RE: Villas at Shadow Pines  
City File No. 13-009, Section 31  
legal description review

Re: Villas at Shadow Pines Site Condominium PUD      HRC Job No. 20140111  
City File #13-009, Section 31  
Site Plan Review #2

**Subject: File No. 13-009 Villas at Shadow Pines PUD;  
Wetland Use Permit Review #2;  
Plans received by the City of Rochester Hills on  
April 8, 2014**

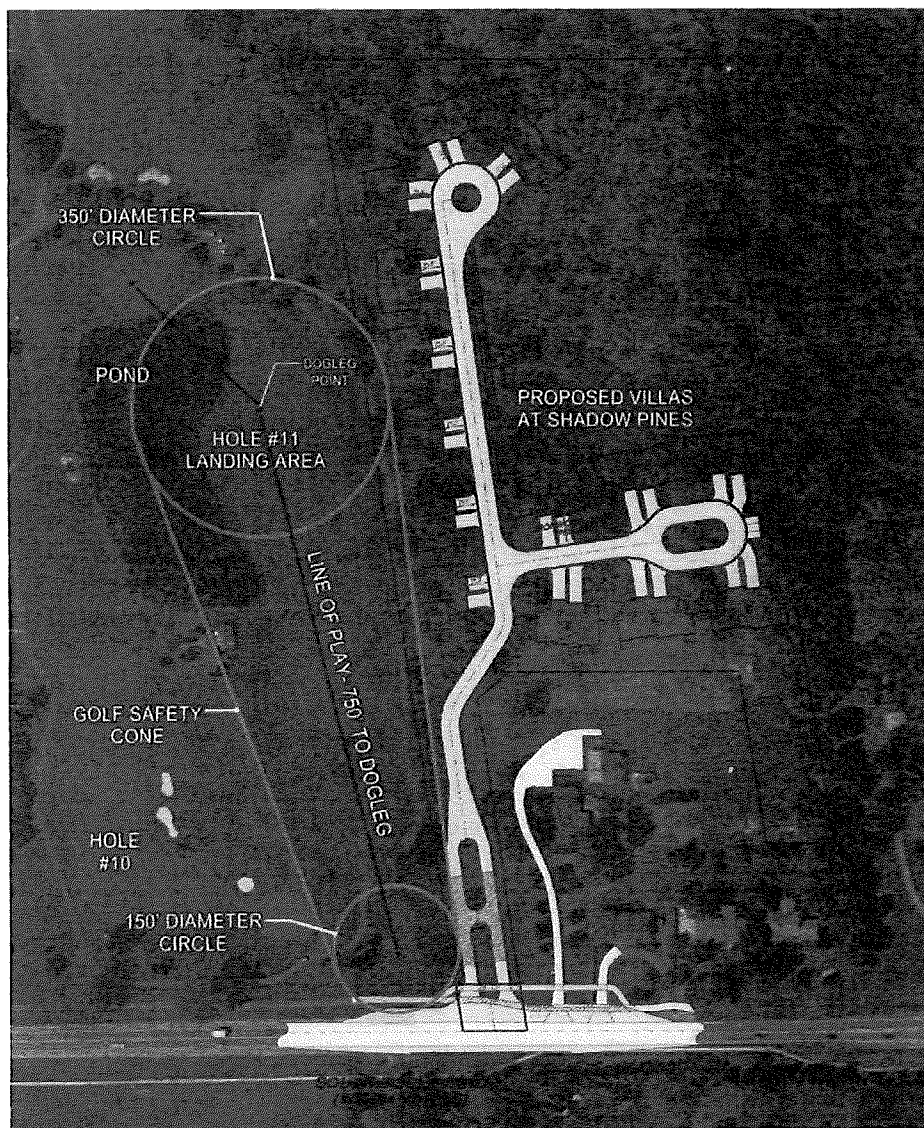
The drawing below shows the standard and accepted golf safety cone laid over the top of hole #11 at Pine Trace. The right side of the safety zone rests along the edge of the property line along the east side of the hole. The safety zone slightly encroaches into the proposed Shadow Pines condominium development but does not overlap the proposed buildings.

Based upon the width of the landing area at hole #11 and the footprint of the golf safety cone I believe that hole #11 at Pine Trace can function adjacent to the planned Shadow Pines residential development. The proposed condominium buildings fall to the outside of the golf/residential safety cone that was laid over hole #11.

Proposed Design Modifications for Hole #11 at Pine Trace GC:

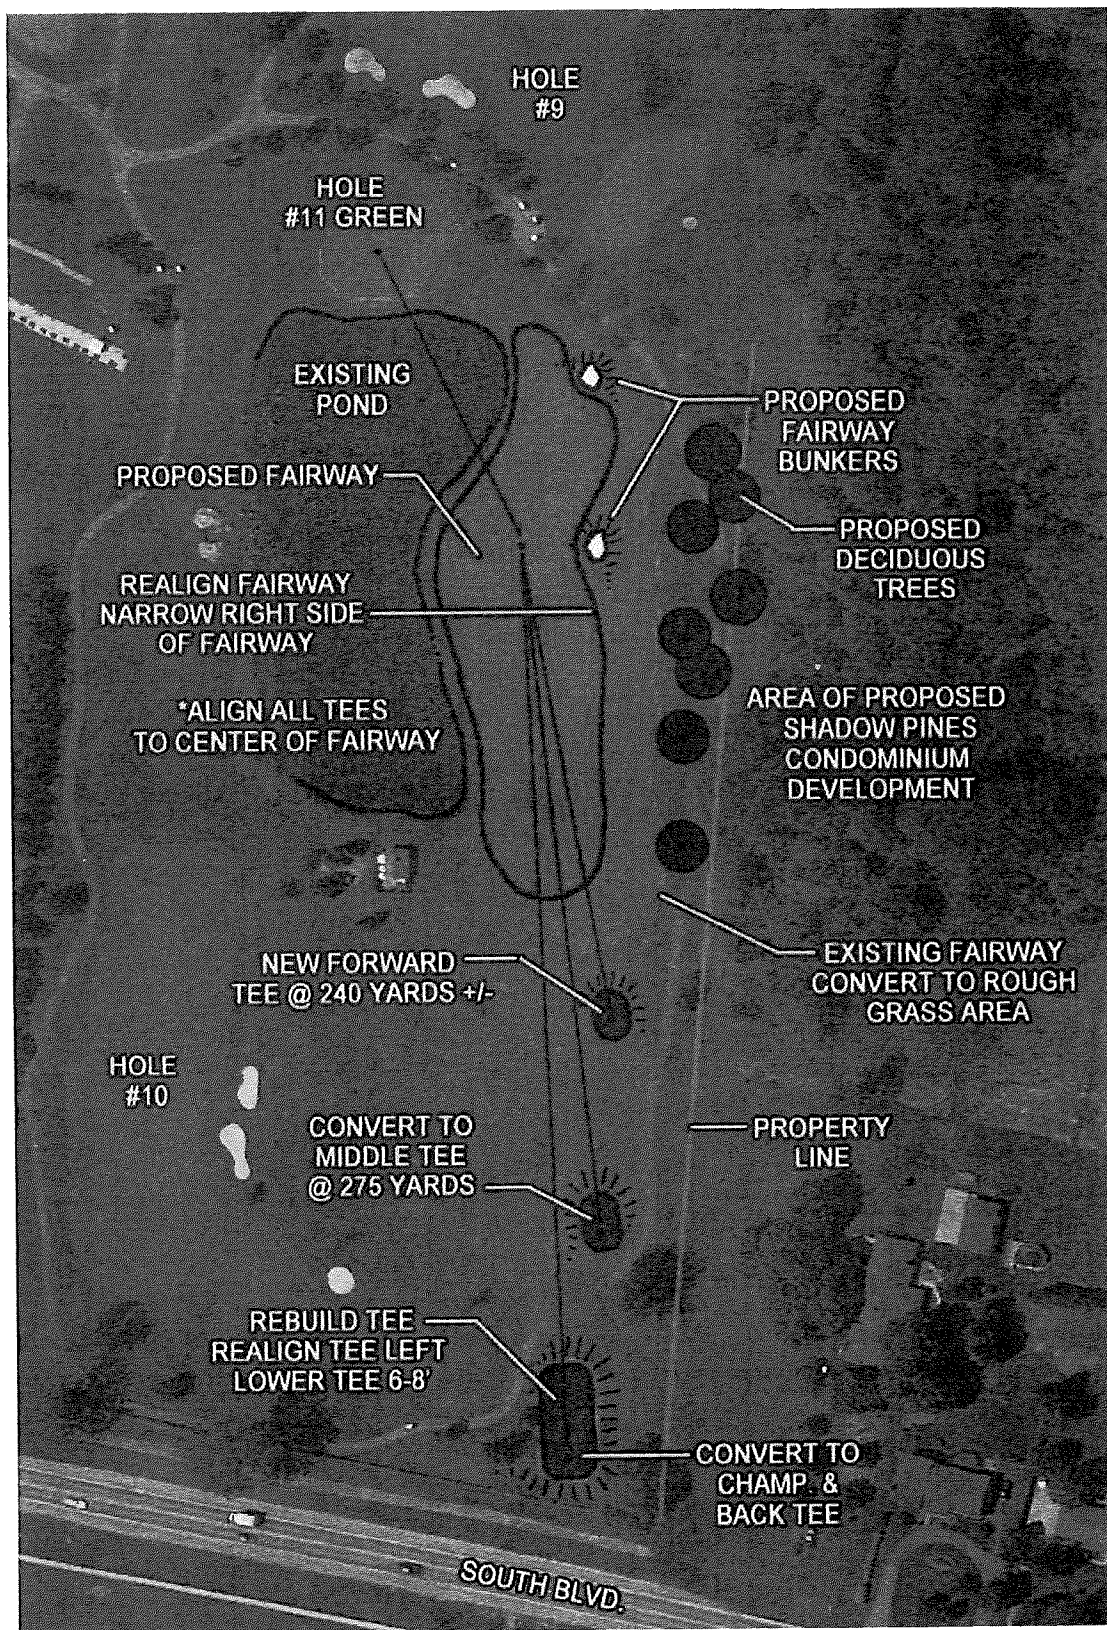
Pine Trace GC- Hole #11 Design Modification Recommendations:

1. Rebuild and realign the back tee box 15 degrees +/- to the left of where it is currently aligned. The tee should be aligned to the center of the fairway landing area.

2. Realign the forward tee box 5 degrees +/- to the left of where it is currently aligned. The tee should be aligned to the center of the fairway landing area.

3. Rebuild and lower the back tee 6-8' in elevation.
4. Rearrange the tee markers so that only the Championship and Back tee markers are on the back tee (there are currently 3 tee markers on this tee). Move the Back tee marker to the front half of this tee.

5. Move the Middle tee marker to the location of the current forward tee. The Middle tee would be 275 yards versus the current 316 yards.
6. Add a new forward tee near the beginning of the fairway. The new forward tee would be 240 yards +/-.

7. Narrow the right side of the fairway. The fairway is currently 140' to 170' in width. Shift the right side of the fairway 50'-70' to the left (west). The narrower fairway will help golfers focus to the center of the landing area and align properly. For reference hole #11 has one of the widest fairways at Pine Trace. Most of the holes have fairways that are 100' +/- in width.

8. Add 7-10 new deciduous trees along the right side of the landing area. The trees should be located adjacent to the existing cart path.
9. Add two (2) fairway bunkers along the right side of the fairway landing area. One bunker could be located within the existing grass hollow form at the back center of the landing area (within rough area). The second bunker should be located within the mounds along the right side of the landing area approximately 250 yards from the back tee.
